APPLICANT'S RESPONSES TO RELEVANT REPRESENTATIONS AND ADDITIONAL SUBMISSIONS

Drax Bioenergy with Carbon Capture and Storage

Document Reference Number: 8.3

Applicant: Drax Power Limited

DRAWING NUMBER
 EN010120-PA-FCA-EC-30

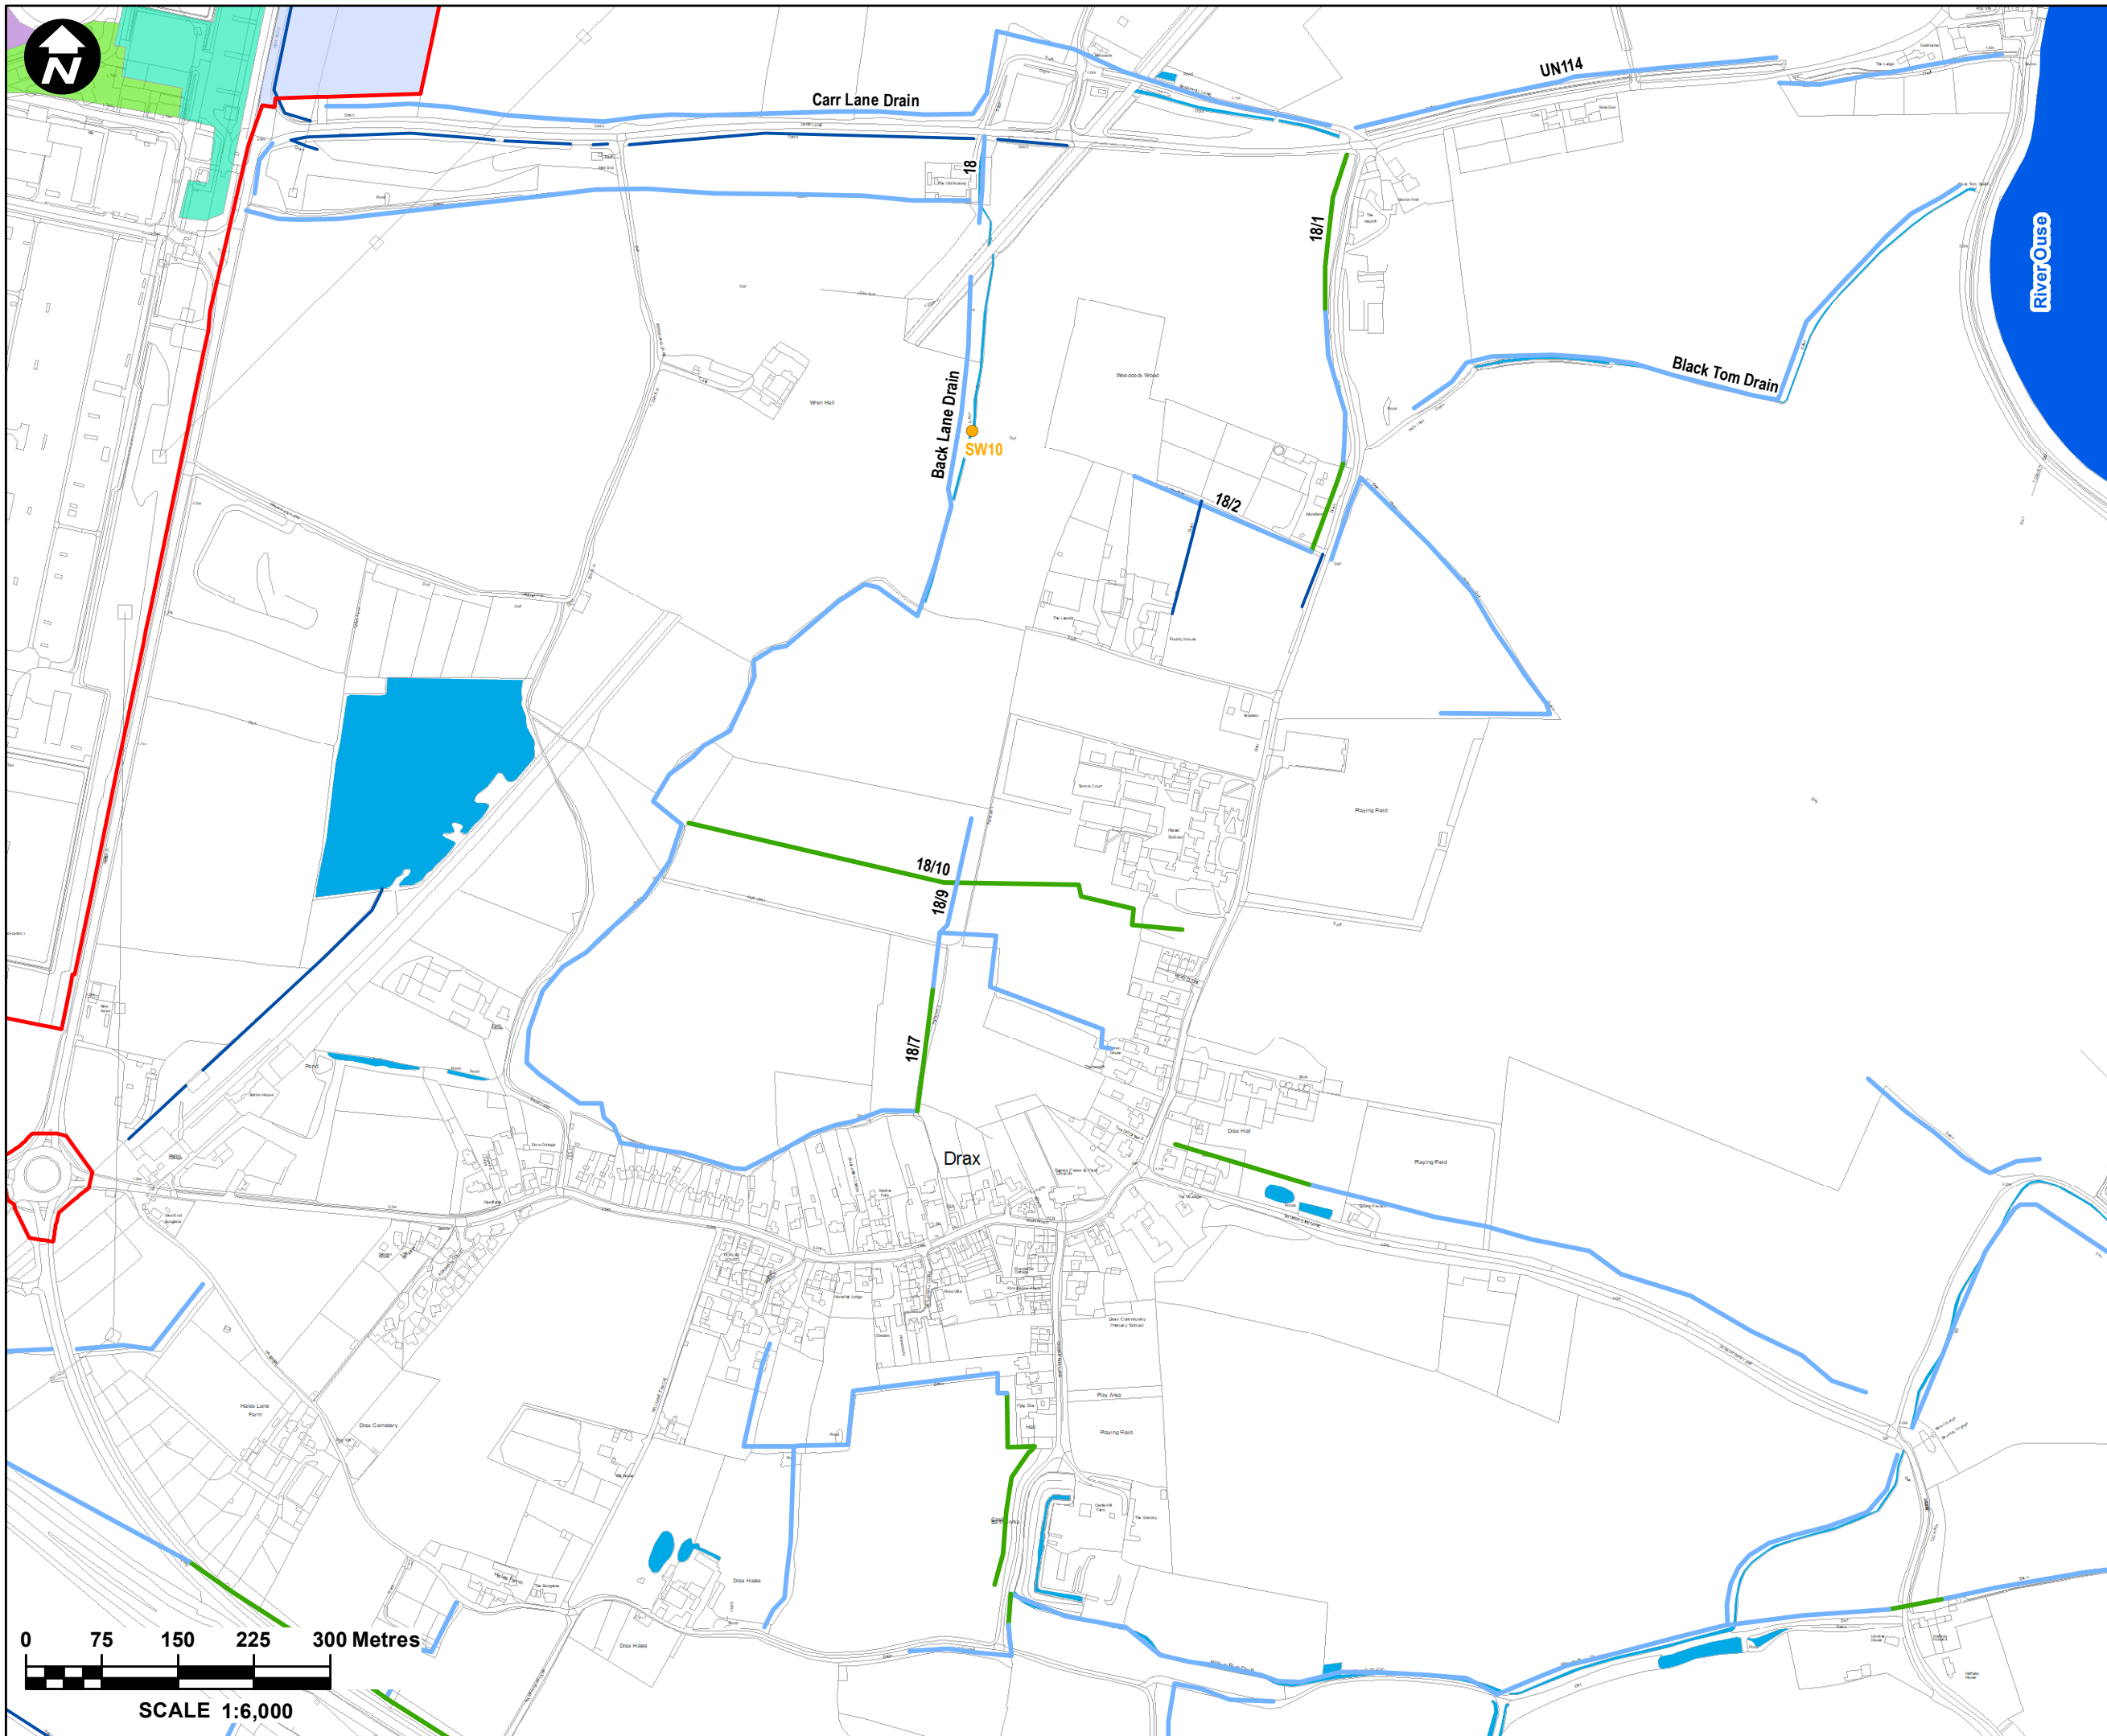
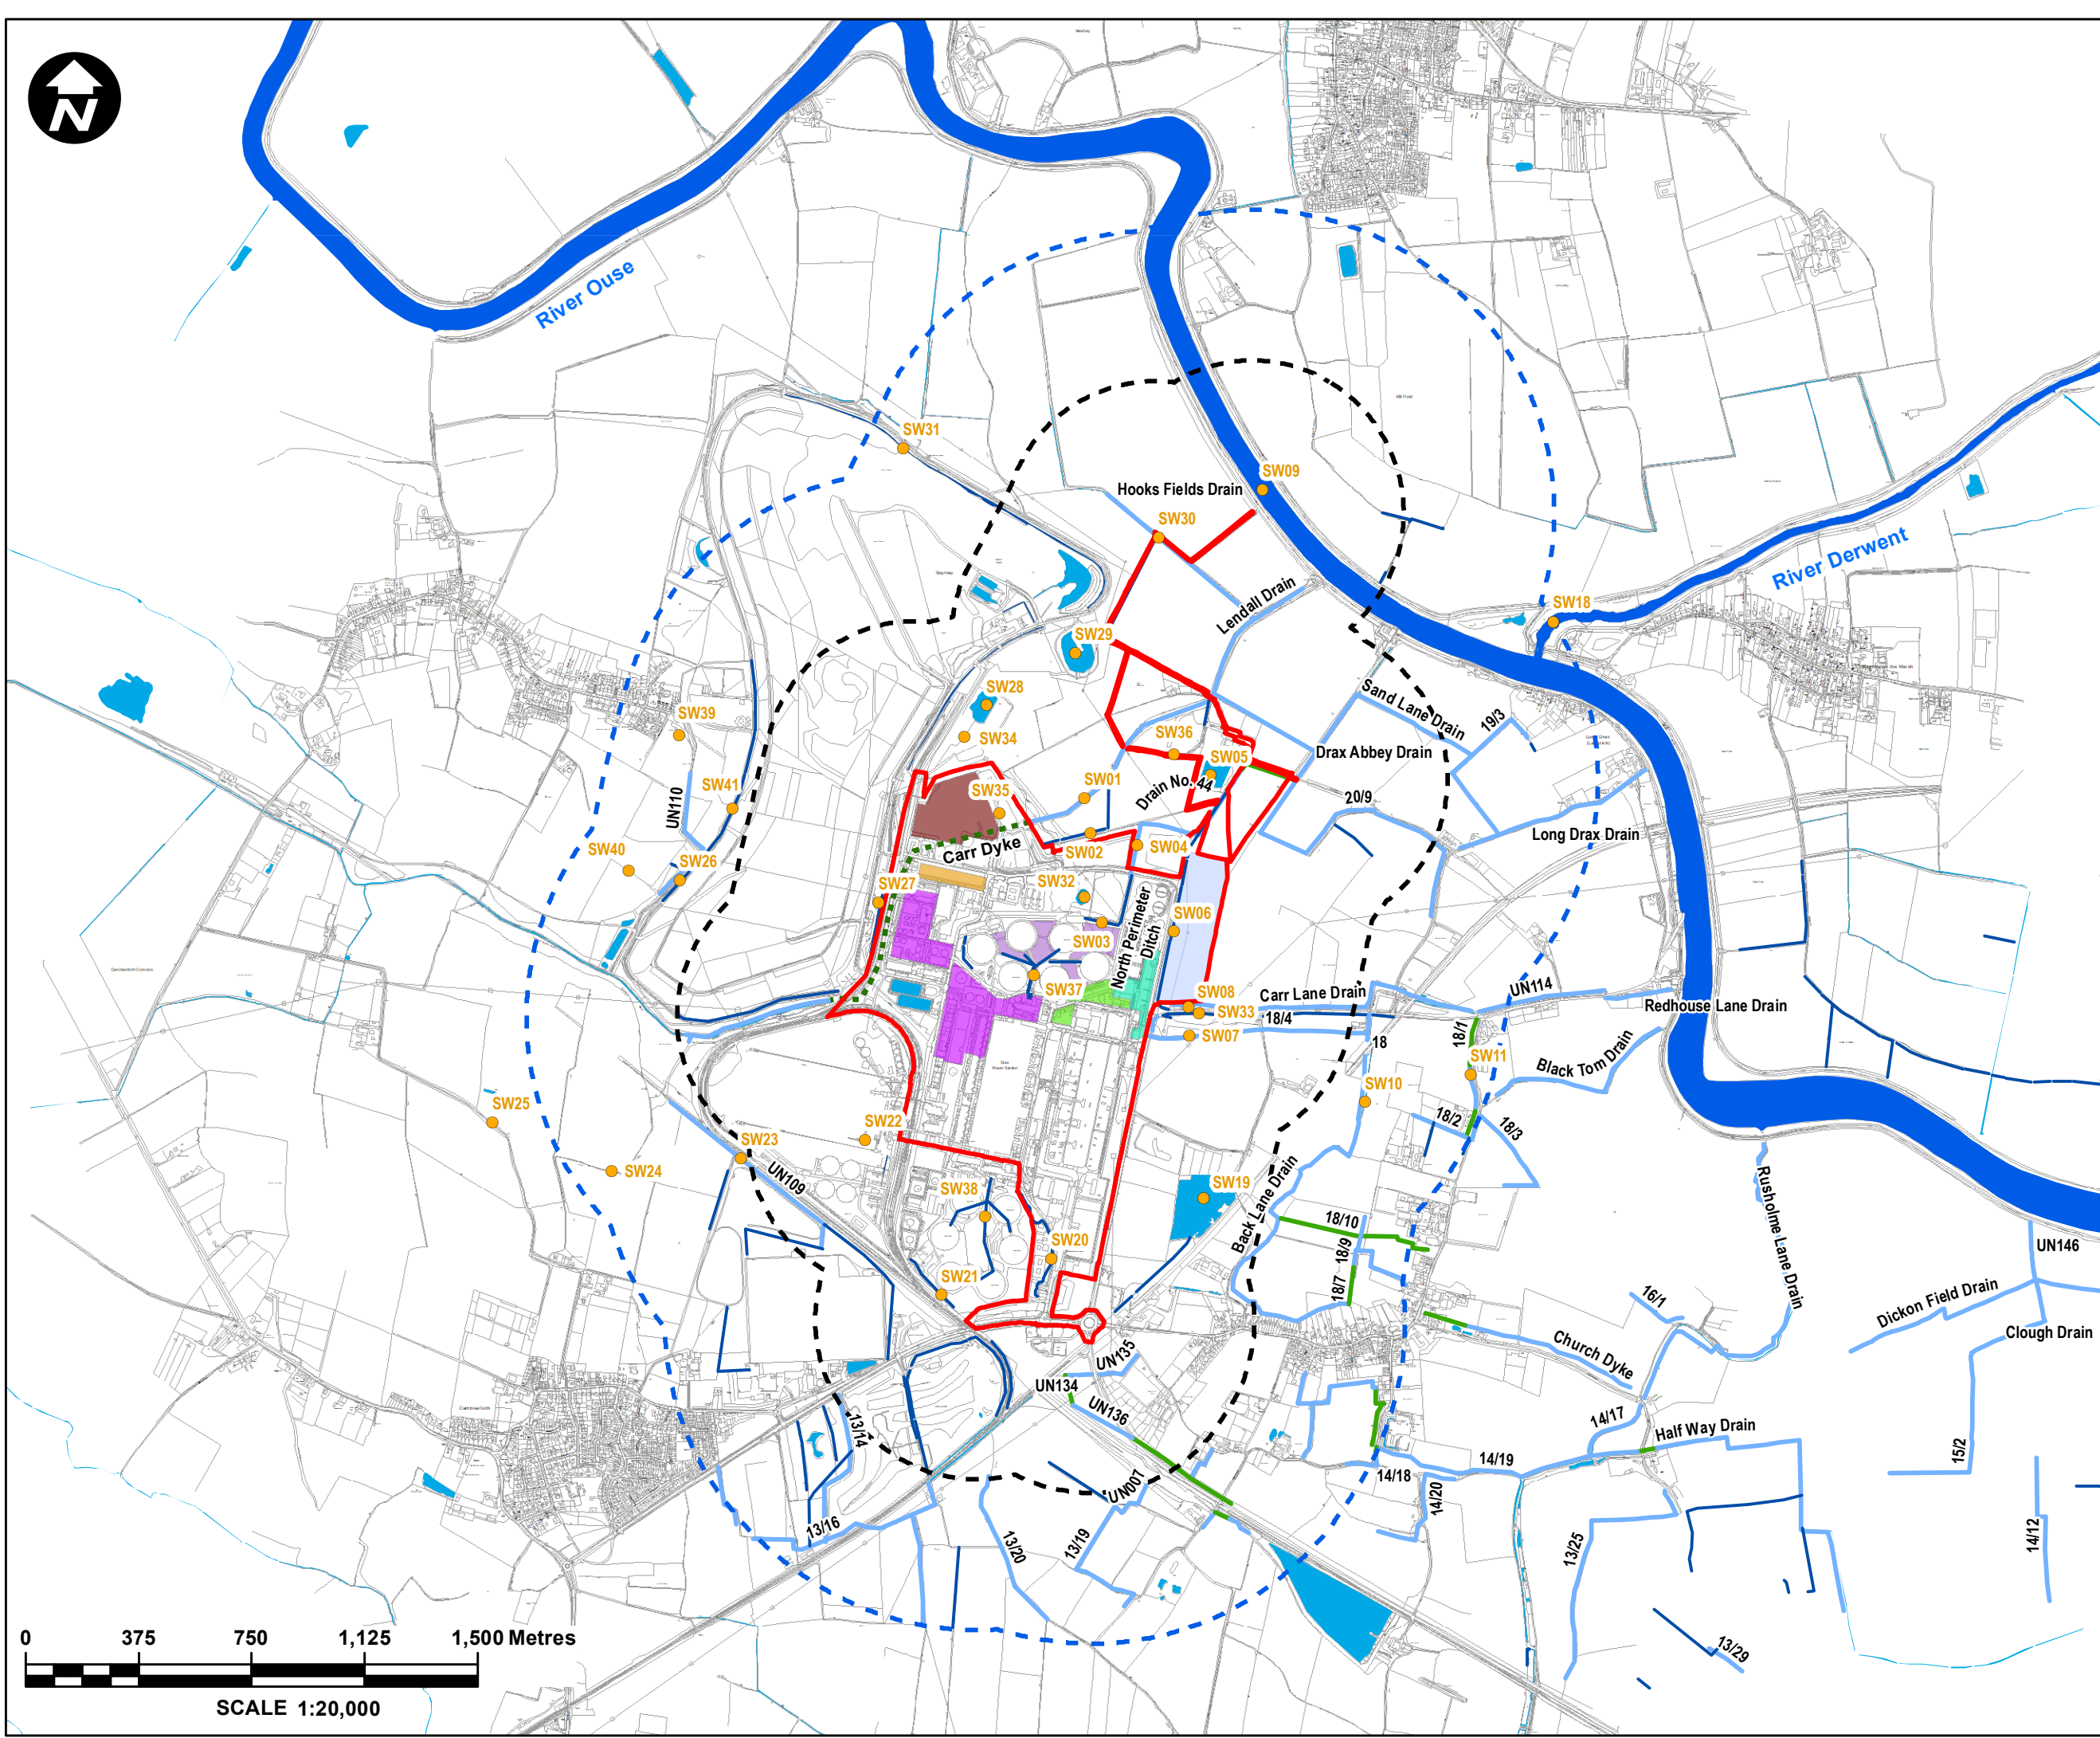
4.5	<p>Table 12.6 Surface Water Features within the study area that have the Potential to be Affected by the Proposed Scheme. Several of the ponds within this table which have a recorded presence of Great Crested Newt are not considered as 'sensitive receptor'. We disagree with this as they may be a habitat of the Great Crested Newt, which is a protected species and therefore a 'sensitive receptor'.</p>	<p>Whilst these ponds could be considered as a sensitive receptor as the presence of Great Crested Newt has been recorded / provide suitable habitat, they are not likely to be affected by the construction of the Proposed Scheme given that they are separated from the Proposed Scheme and Construction Areas, by an earth embankment, as shown in the image below, which would prevent any pollutants / contaminants which are accidentally released from the construction of the Proposed Scheme from reaching them.</p>

Figure 1. Illustration of modelled operating hours for the 4 x Units in the Full Load and Mid Merit Scenarios

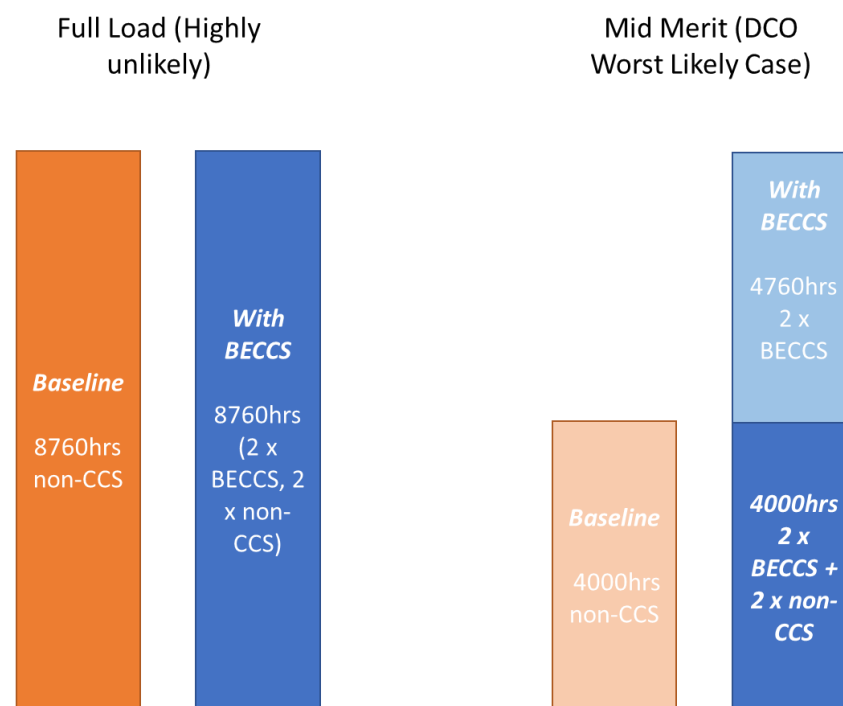
A standard assessment for a power station would be based on the full load operation of the power station both with and without any proposed changes. Since the Proposed Scheme involves fitting CCS to existing generation units, the Full Load operations involve 8760 hours of operation of 4 x units in both the baseline and With Scheme scenarios, with 2 of these units being BECCS units with the Proposed Scheme. This is illustrated in the left section of Figure 1.

With the Proposed Scheme and the relevant Government support mechanism (a Contract For Difference (CFD) which encompasses both power and carbon) in place it is highly likely that the operation of units with CCS will be more economically advantageous than operation of the non-CCS units since support on these current units will cease in 2027 and hence a future full load scenario is considered unlikely and a more intermittent operating regime would more likely result. To ensure a robust, worst-case assessment, a Mid-Merit scenario has been modelled as illustrated in the right-hand section of Figure 1. It involves 4 units (non-CCS) operating for 4000 hours in the baseline without the Proposed Scheme, and with the Proposed Scheme, the 2 x CCS units operating for 8760 hours (4000 h + 4760 h), and the 2 x non-CCS units operating for just 4000 of those 8760 hours.

Figure 2. Illustration of modelled air quality impacts for Full Load and Mid Merit Scenarios

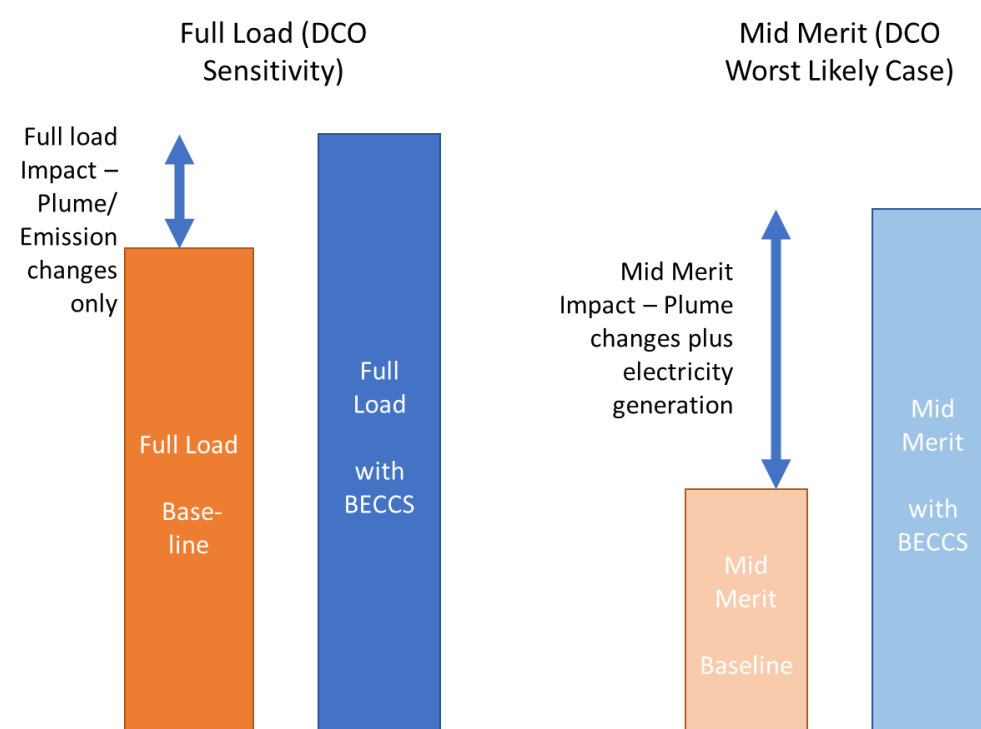
With an assessment based on Full Load operations, whilst the contribution of the plant to local concentrations of pollutants is maximised in both the Baseline and the With BECCS scenarios, the **impact** of BECCS is determined solely by the balance of the beneficial impacts of reduced pollutant concentrations and the adverse impacts of the change plume buoyancy (and a net slight disbenefit). This is illustrated in the left panel of Figure 2.

In the Mid Merit Case, the contribution of the plant to pollutant concentrations is reduced in comparison to the Full Load case, since the units are not all operating continuously in either Baseline or With BECCS scenarios. However, the **impact** of BECCS now includes both the plume/emission changes and the impacts of the likely increase in operating hours. This is illustrated in the right panel of Figure 2.

Figure 3. Illustration of modelled air quality impacts for Mid Merit Scenario without 3 unit operations (as modelled for ES, DCO Worst Likely Case) and with part use of 3 unit operations (Alternative Likely Case)

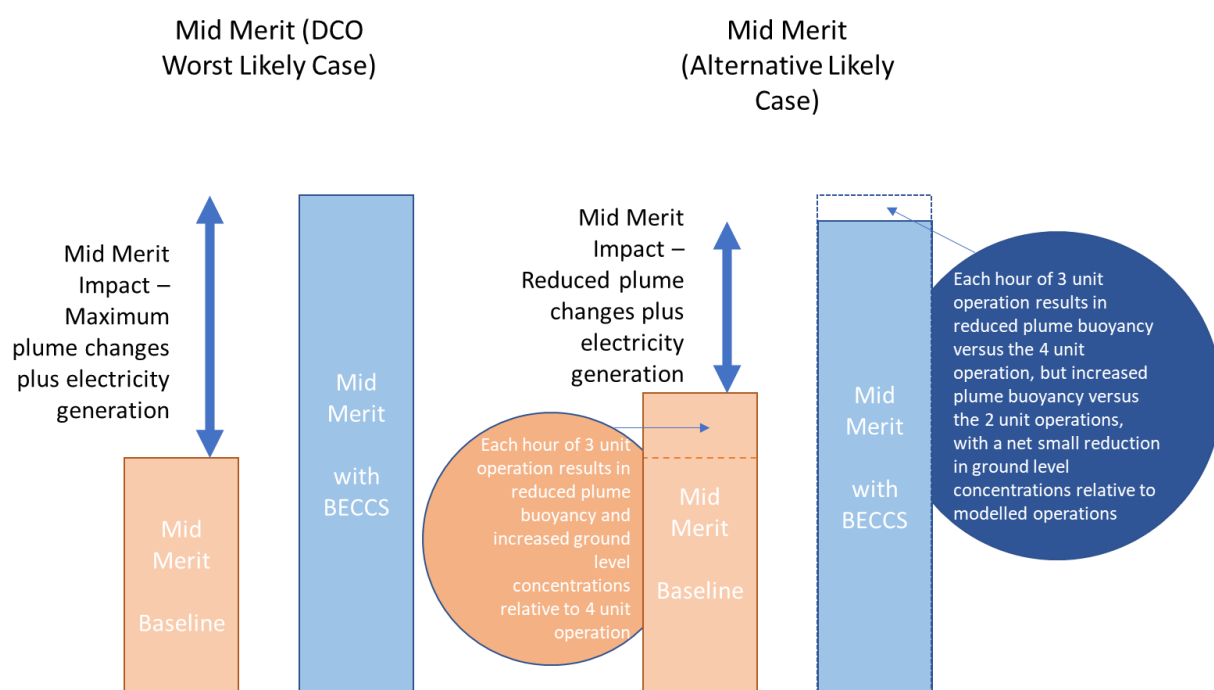
Such operations will lead to a reduction in the modelled impacts for the Mid Merit scenario. This is illustrated in Figure 3.

It must be noted that in the Baseline, moving any of the 4000 hrs for each unit operating from 4 to 3 unit operations (whilst maintaining the total operating hours/electricity production) results in **increased** process contribution at ground level because the buoyancy of the plume is reduced with 3 units in comparison to 4 units. For the with BECCS scenario, if you move from 4 unit operation to 3 unit operation, you must then replace one or more hours of 2 BECCS unit operation with 3 unit operation. Whilst the 4 to 3 unit operation change results in reduced plume buoyancy, the 2 to 3 unit change results in increased plume buoyancy, with the net effect that ground level concentrations decrease slightly. Overall the changes then result in a **reduced** impact in comparison to the modelled Mid Merit scenario.
